January 28, 2010 ASB221E

INSPECTION OF MODEL 1A103/TCM PROPELLER HUB FOR CRACKING AND REWORK PROCEDURES

1A103/TCM (All Serial Numbers)

ASB221E

Figure 8. Sand Edges of Machining

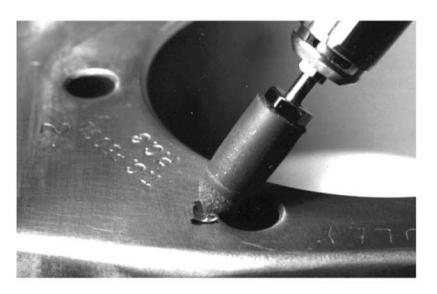
- B. Sand the camber (forward) side of the hub.
 - (1) Sand the camber (forward) side of the hub with sanding bob (Cratex Rubberized Abrasives, part number 11M) to remove any sharp edges. (Refer to Figure 8 and Figure 9.)

Figure 12. Typical Crack Appearance and Location (Sheet 1)

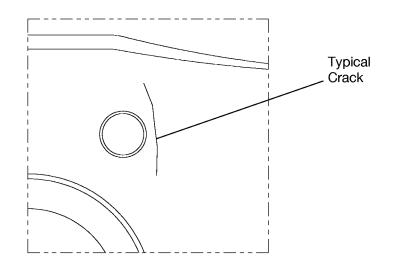
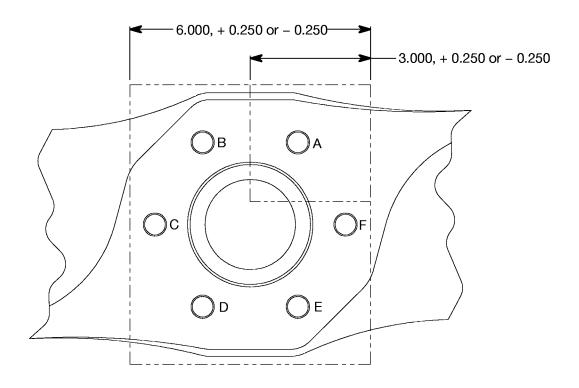
- (2) Anodize the propeller. Refer to the Standard Practices Manual, Protective Treatments 60-00-04, Anodize.
- F. Repaint the propeller hub. Refer to the Standard Practices Manual, Paint Instructions 60-00-06. Do not paint the engine mounting surface of the hub within the dimensioned area as shown in Figure 12.

NOTE: Figure 12. is an illustration of the camber (forward) side of the propeller, transfer the dimensioned area shown to the engine mounting surface (face/aft side) of the propeller hub.

Figure 13. Original Configuration of 1A103/TCMXXXX Propeller and Spinner Installation (Sheet 1)

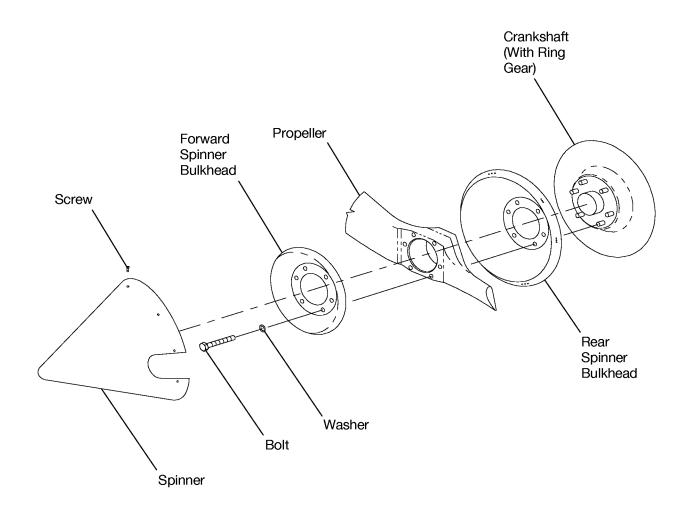
- A. Remove the propeller from the airplane.
 - (1) For propellers that are not in compliance with previous revisions of this service bulletin, refer to the Cessna 152 Series Service Manual and Figure 13.

Figure 14. Reworked Configuration for 1A103/TCMXXXX Propeller and Spinner Installation (Sheet 1)

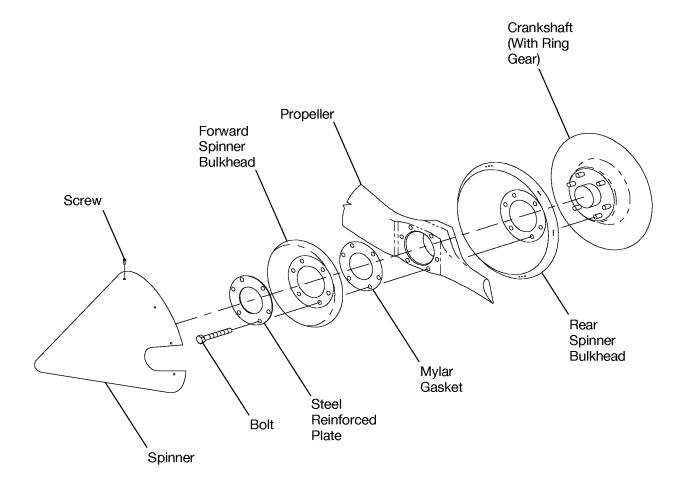
- (2) For propellers that are in compliance with previous revisions of this service bulletin, refer to the Cessna 152 Series Service Manual and Figure 14.

- A. Install propeller (refer to Figure 14.)
 - (1) Clean mating surface of propeller, crankshaft flange, and spinner bulkheads.
